COMPONENT REVIEW FOR TOOLING FEASIBILITY.

1. Plastic material:
2. Shrinkage rate:
3. Cavity No.
- 4 . Mold type:
5. Cavity & core steel:
Cavity
Core :
6. Surface requirement:
Cavity :SPI A2
Core : SPI A2

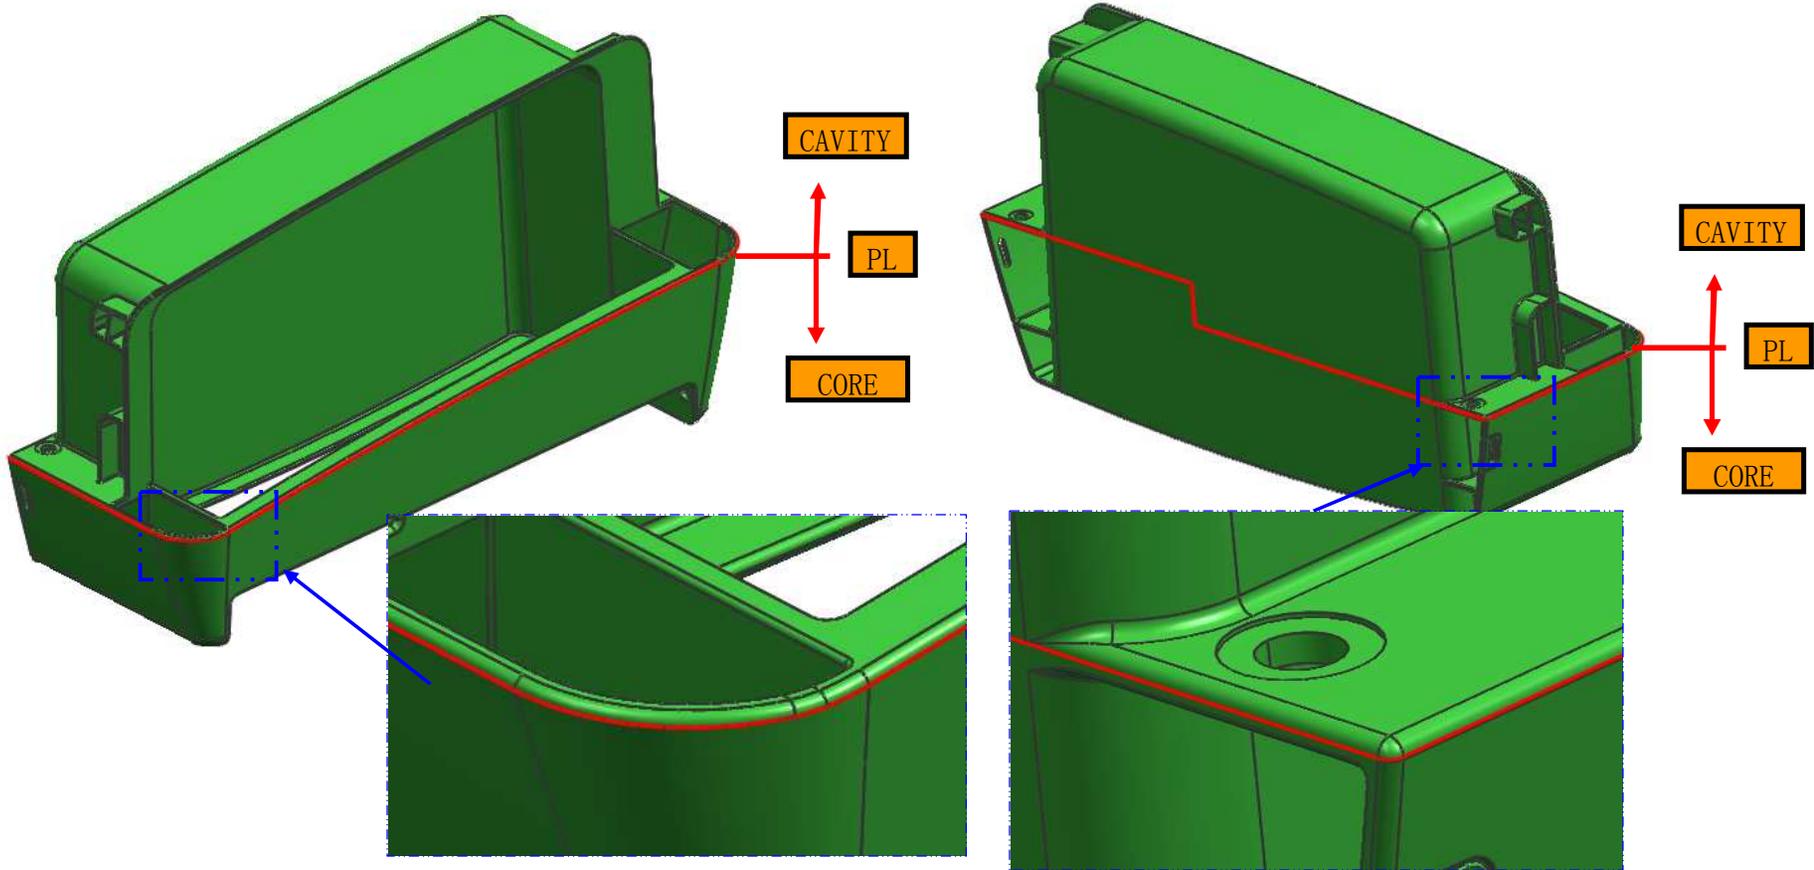
parting lines as shown.

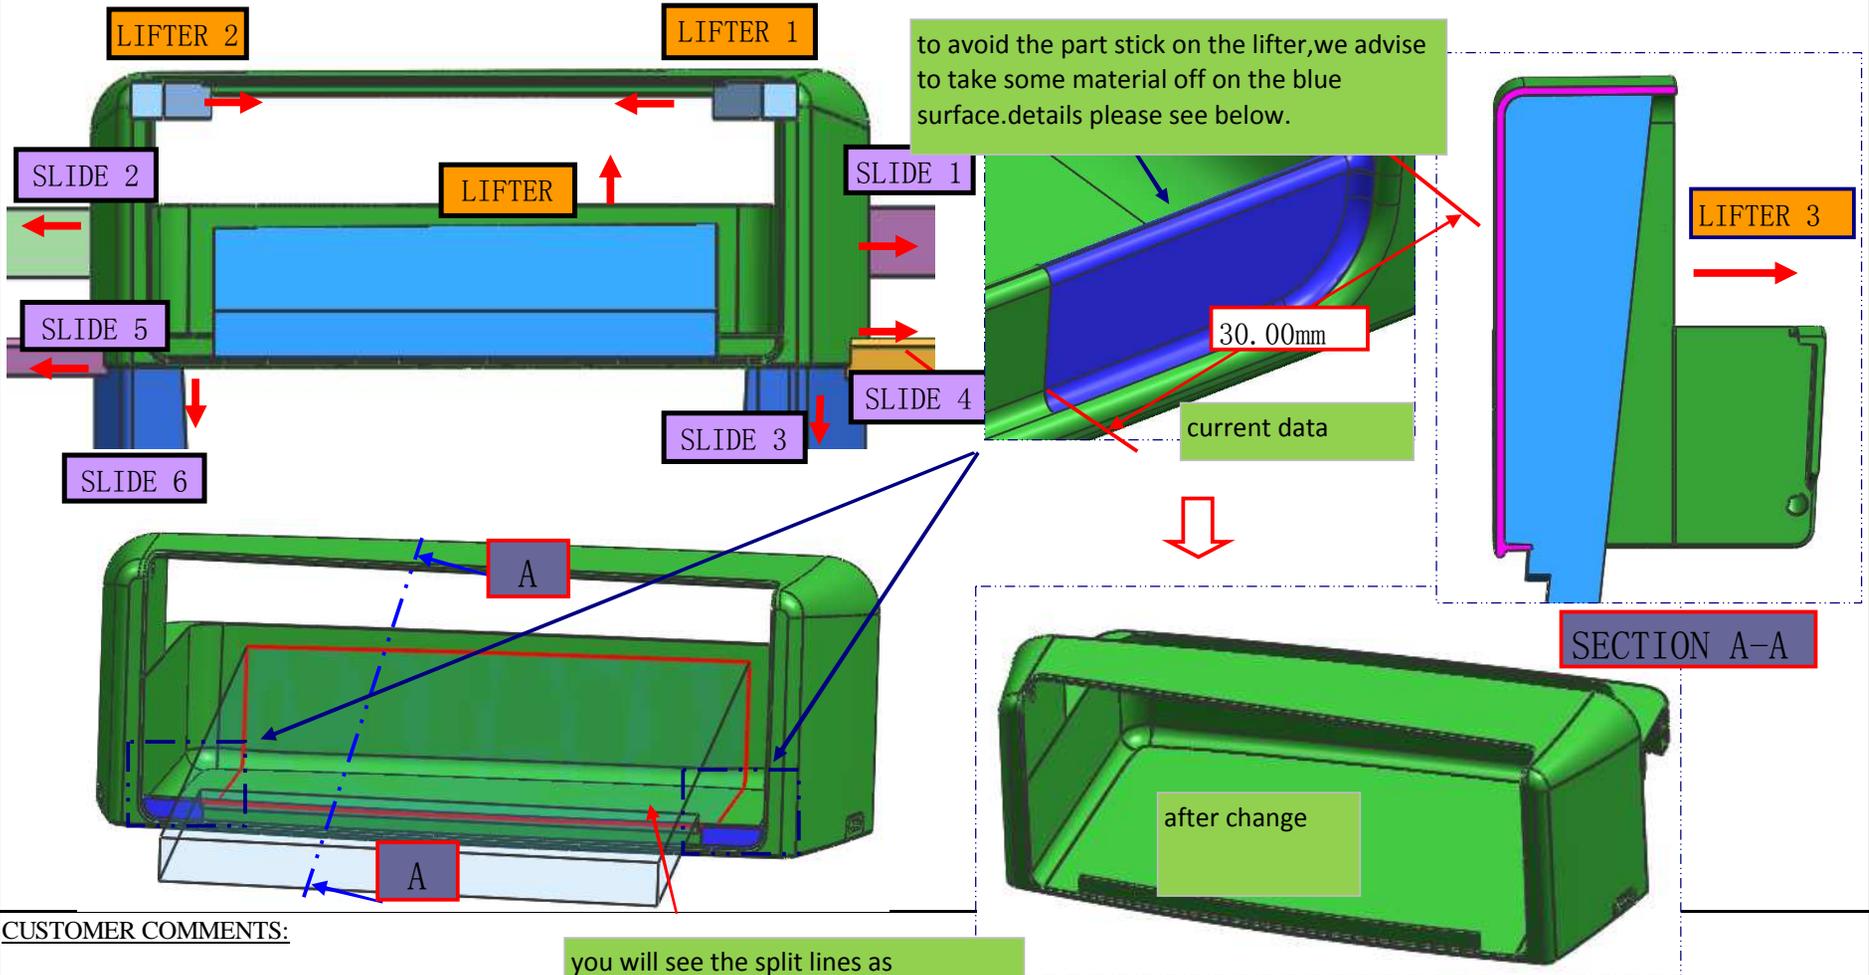
you will see the split lines as shown, are you okay with these?

SECTION A-A

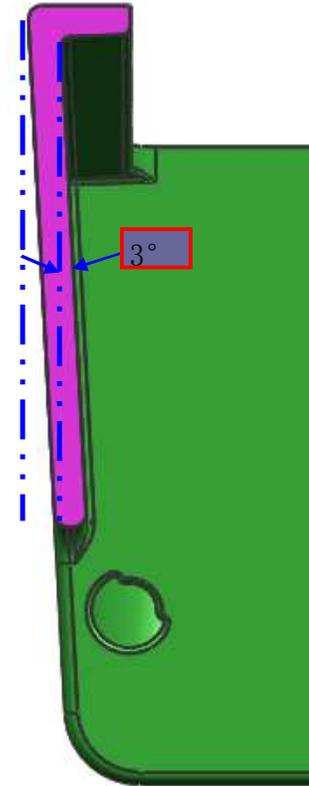
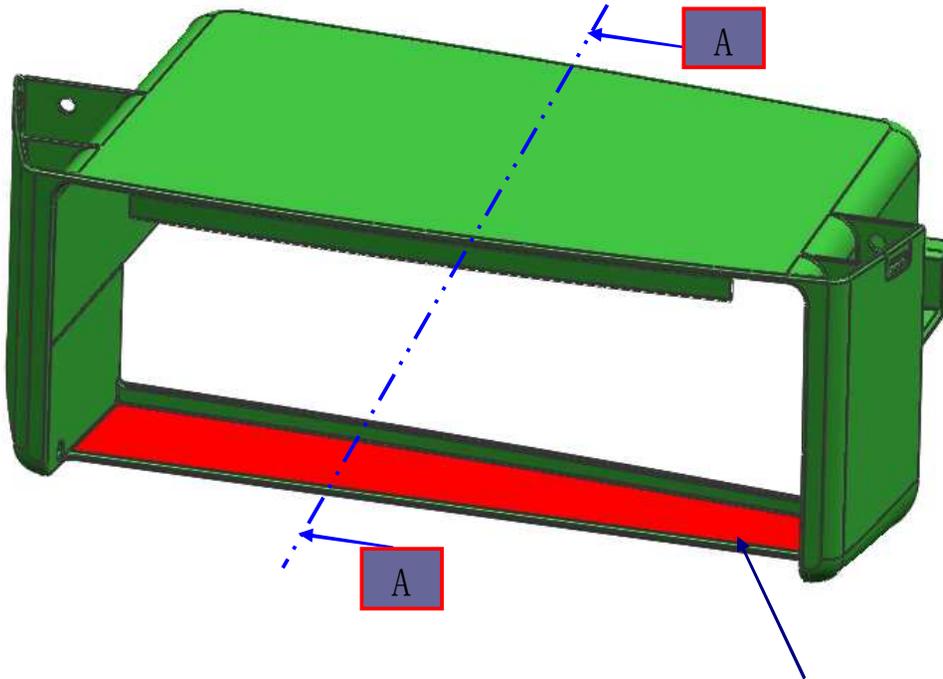
Can you please reverse the draft angle for the red surface(it is a undercut) then put one degree on for demoulding?

Option 1

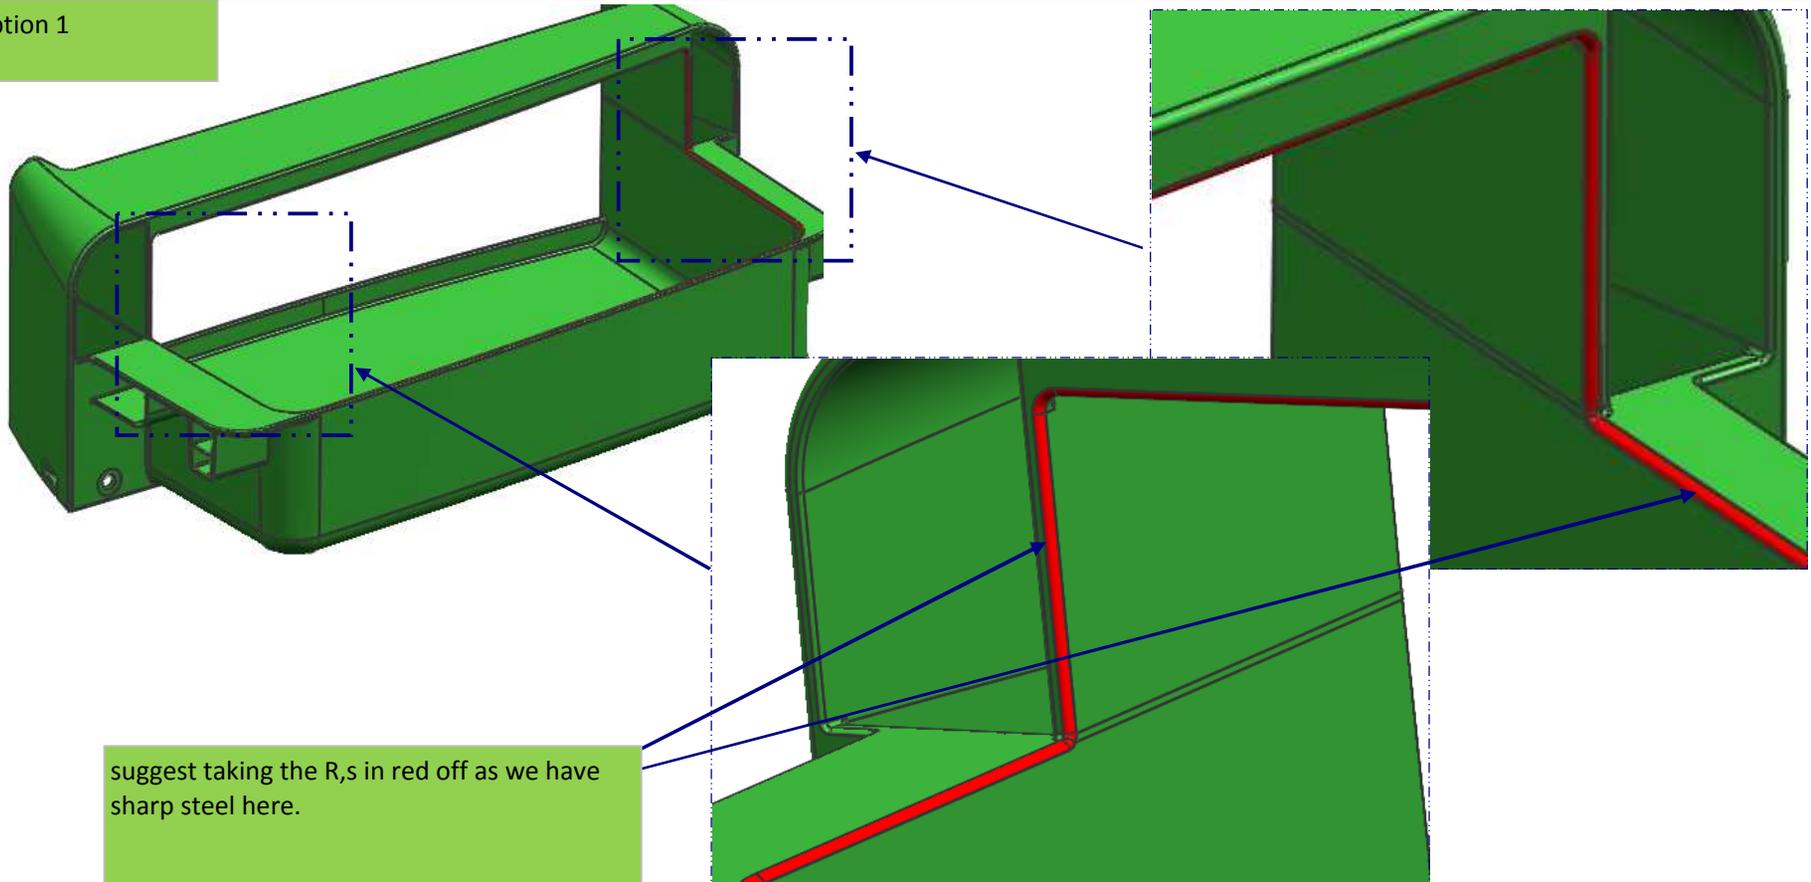
suggest taking the R,s in red off as we have sharp steel here.

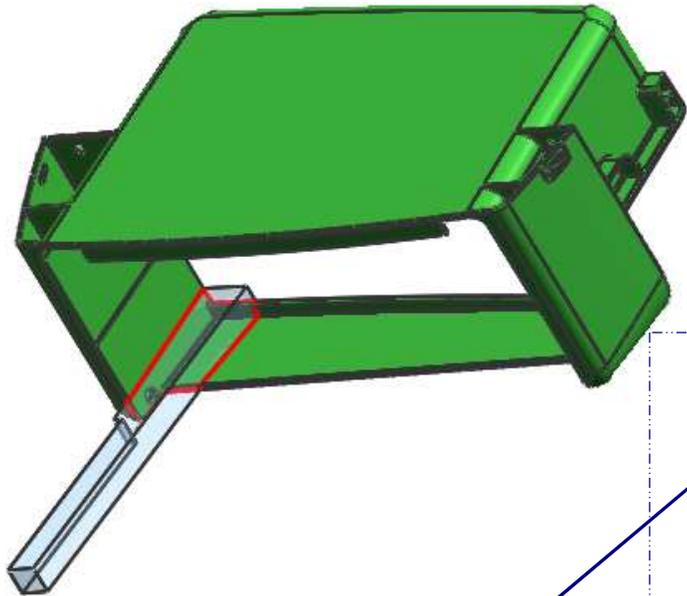
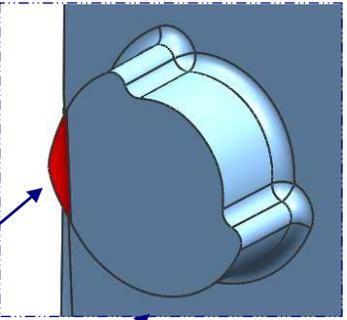
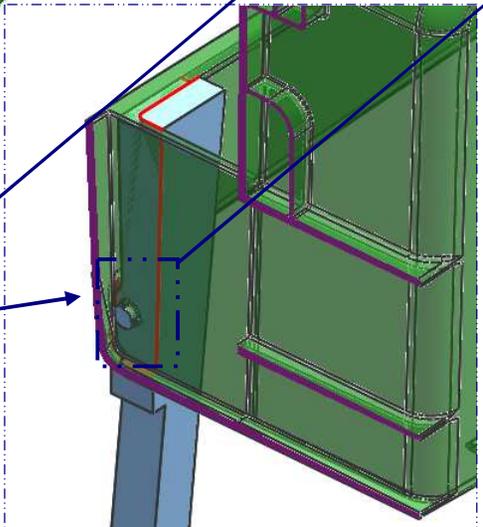
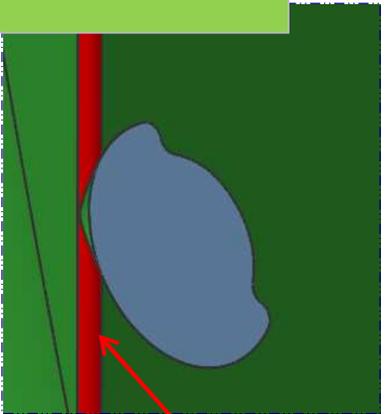
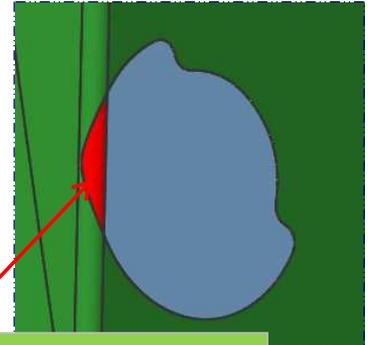
we will have sharp steel here.two options for you refernce to improve this.

Option 1--add material on this area as shown in red

Option 2-remove the R in red.

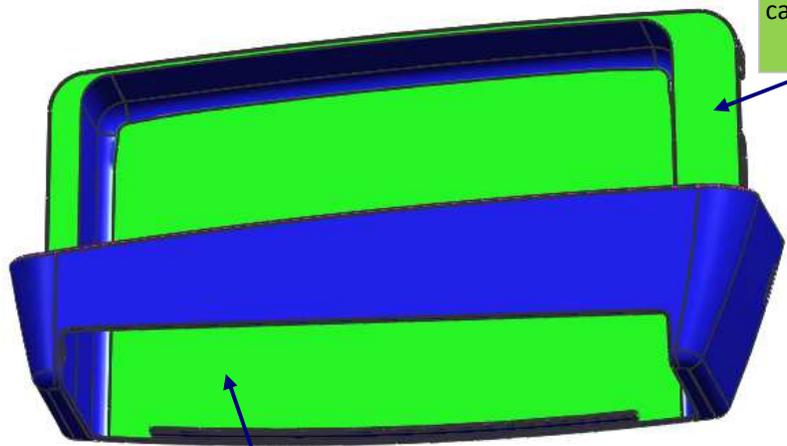
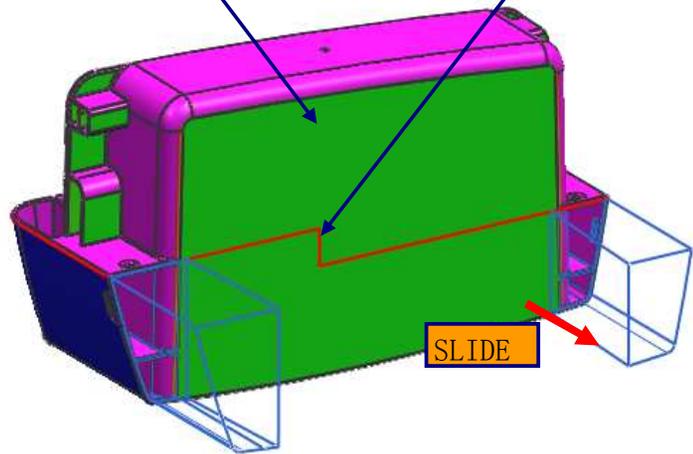
1-Can we add a draft on the green surface by taking 0.15mm off for demoulding -these surfaces will be formed in cavity.

3- there will be a mismatch(0.15mm) here,is it ok?

2-Can we add a draft on the green surface by taking 0.15mm off for demoulding

Section A-A

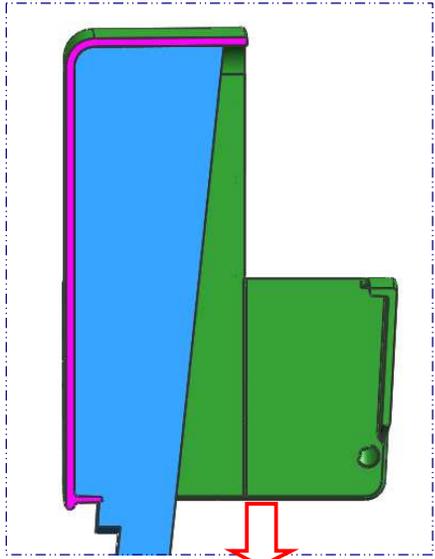
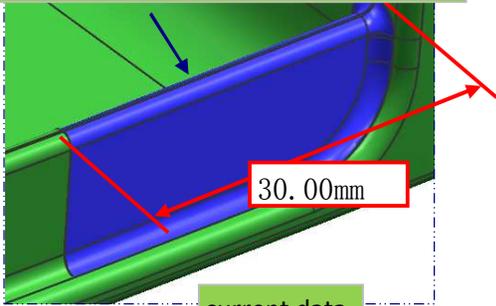
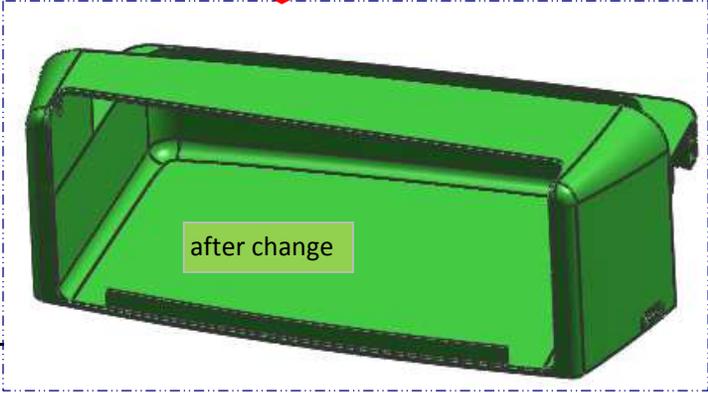
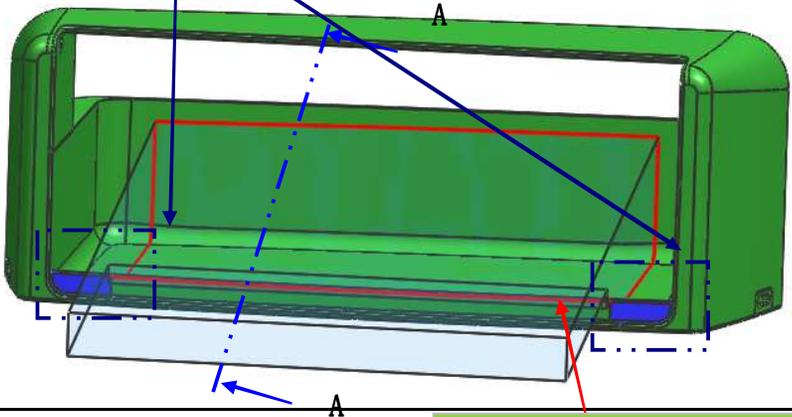
to avoid the part stick on the lifter,we advise to take the material off showing in blue surface.details please see below.

you will see the split lines as shown,are you okay with these?

Section A-A

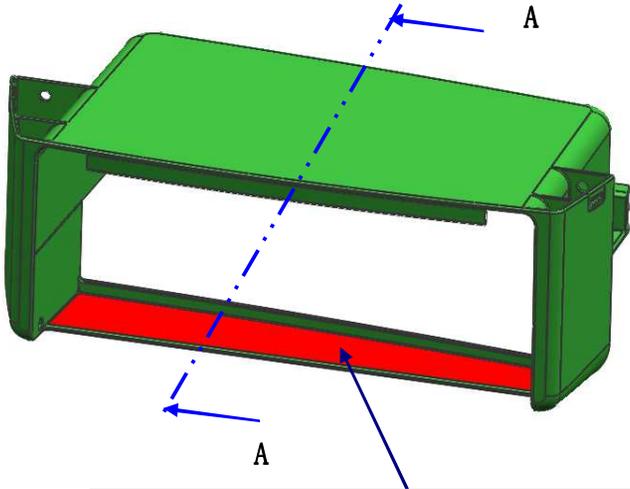
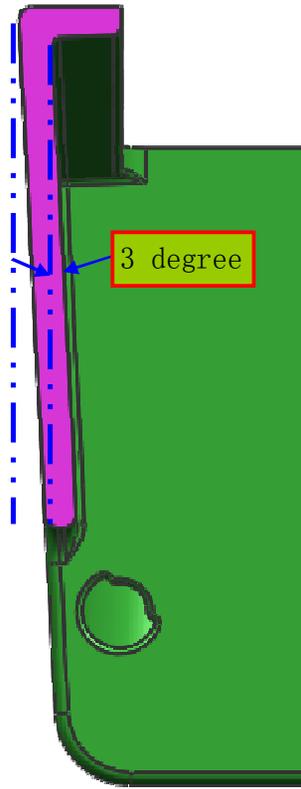
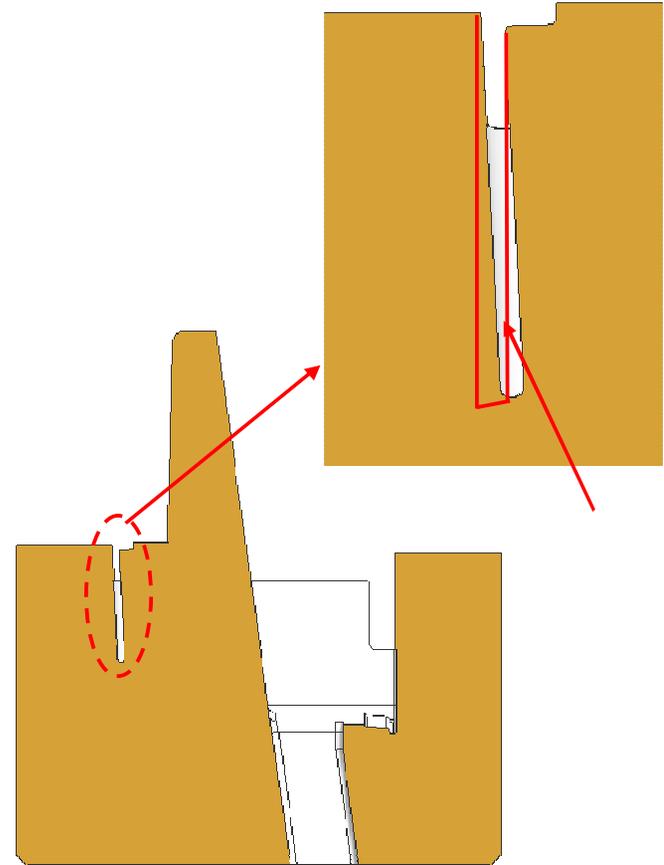
Can you please reverse the draft angle for the red surface(it is a undercut) then put one degree on for demoulding?

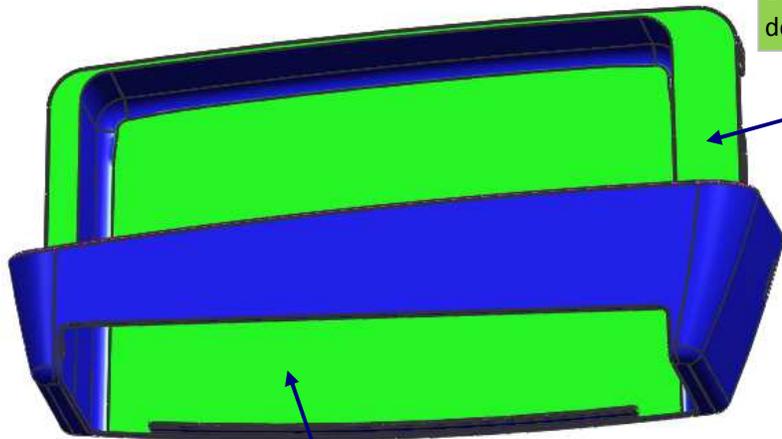
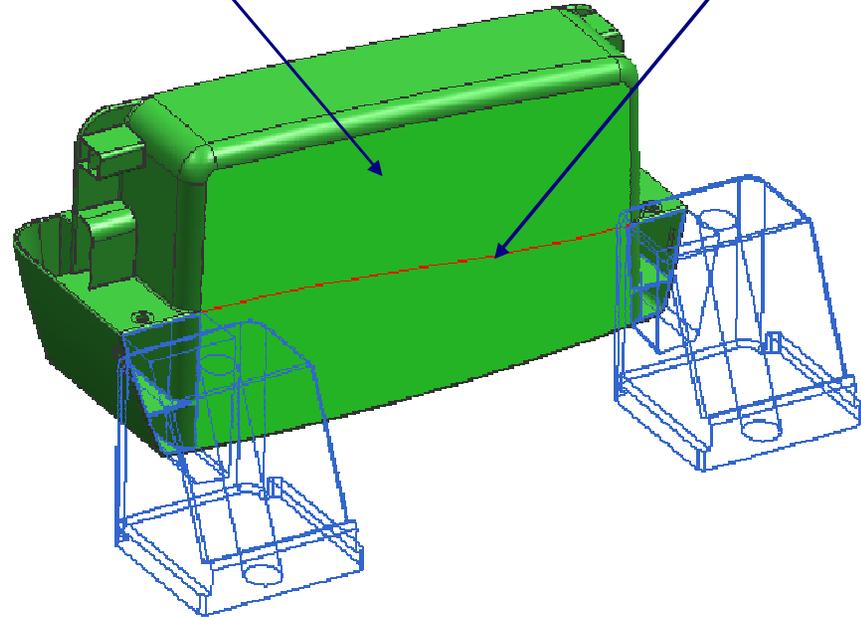
2-Can we add a draft on the green surface by taking 0.15mm off for demoulding

1-Can we add a draft on the green surface by taking 0.15mm off for demoulding -these surfaces will be formed in cavity.

3- there will be a mismatch(0.15mm) here, is it ok?
